Comments in magenta red provided by
Slantern@auroragov.org (Drainage)

Preliminary Drainage Report For Foundry Filing No. 1

Aurora Water Drainage

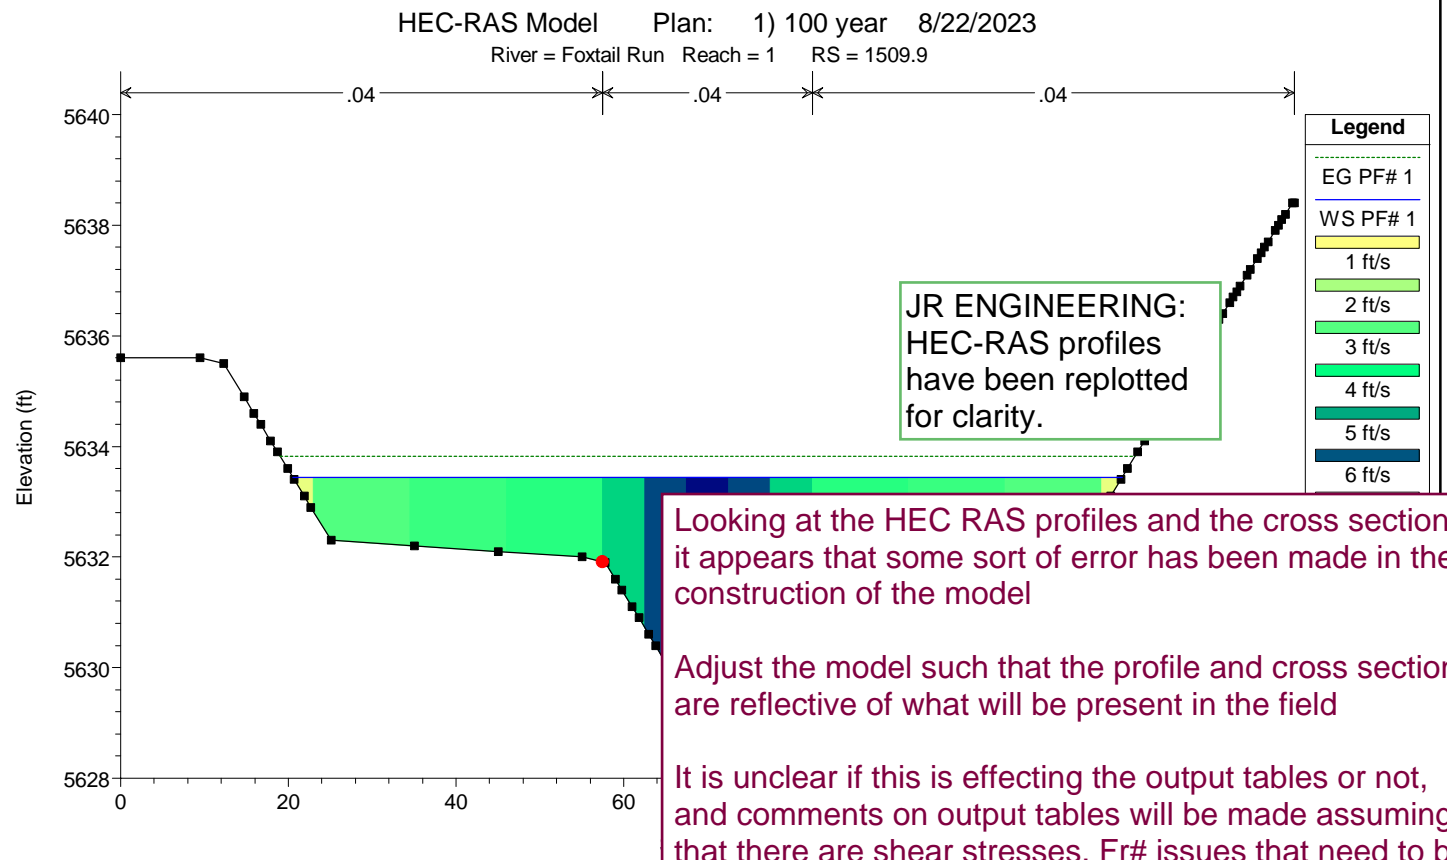
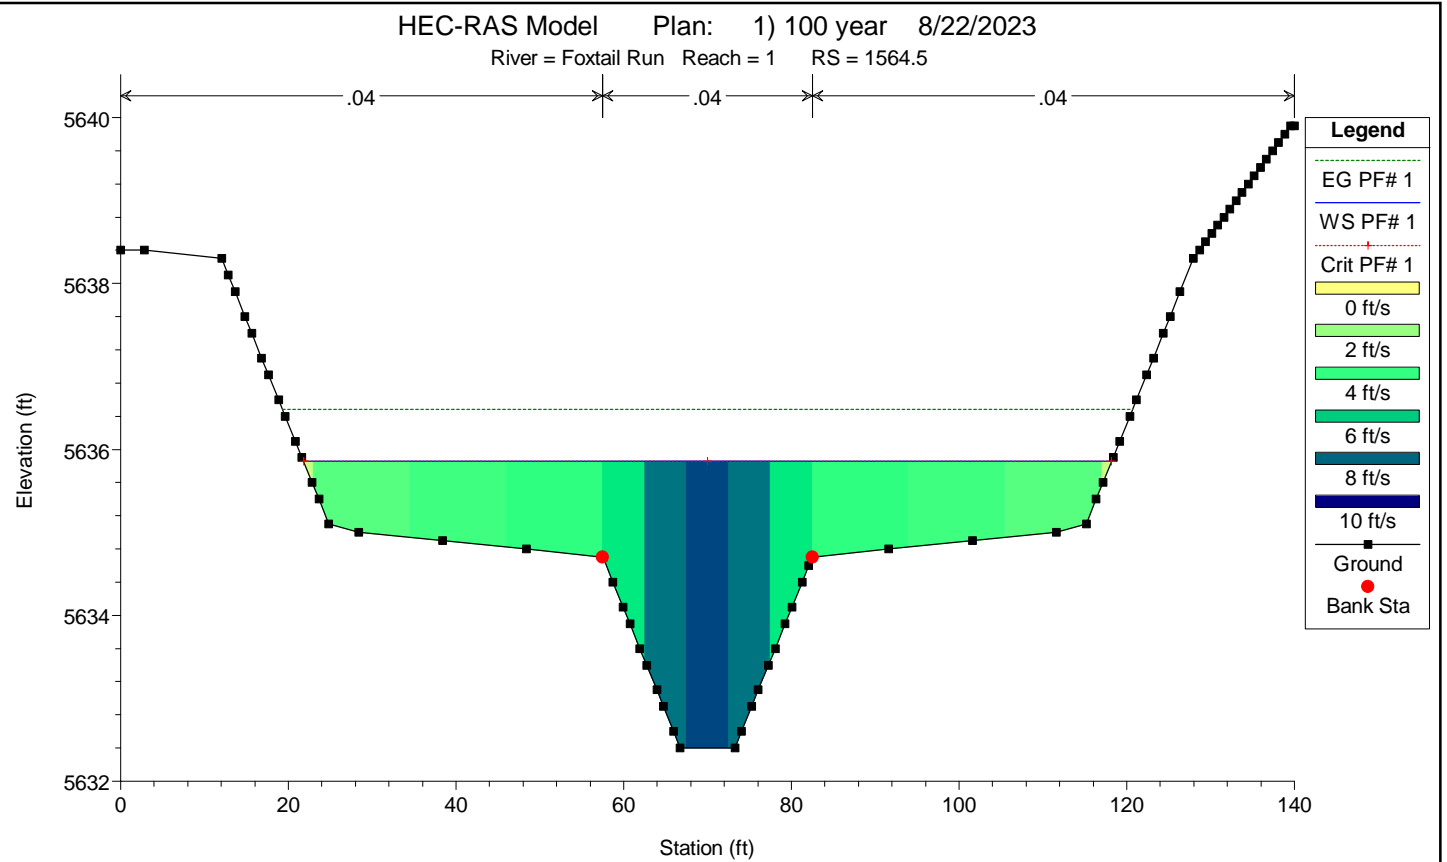
Adjust the model such that the profile and cross sections are reflective of what will be present in the field

It is unclear if this is effecting the output tables or not, and comments on output tables will be made assuming that there are shear stresses, Fr# issues that need to be addressed

Looking at the HEC RAS profiles and the cross sections, it appears that some sort of error has been made in the construction of the model

DETENTION BASIN STAGE-STORAGE TABLE BUILDER

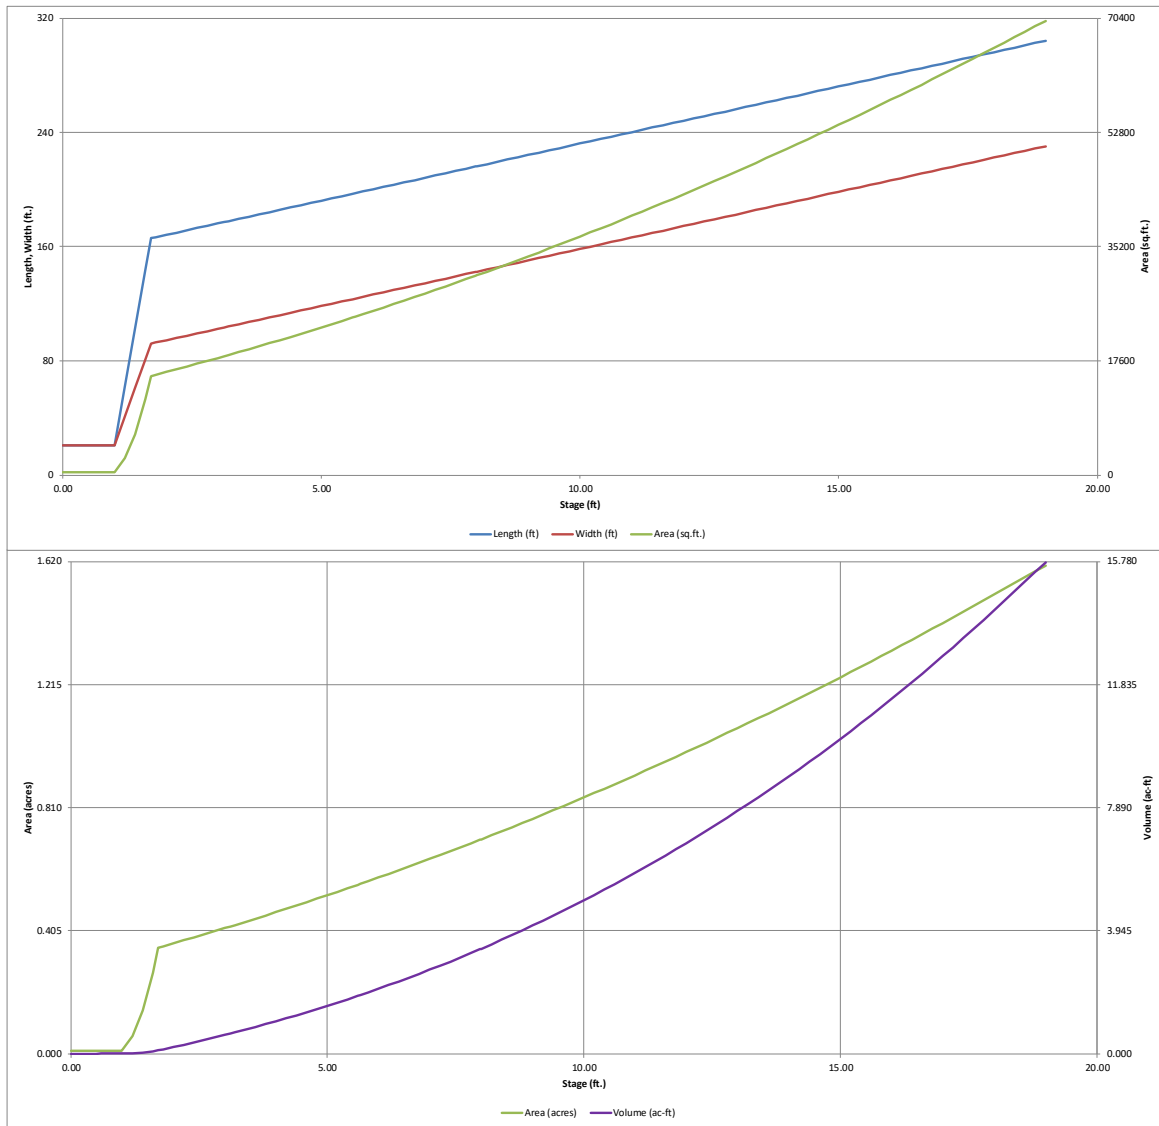
NOTE: Outlet structure and orifice sizing are preliminary and not approved with this submittal
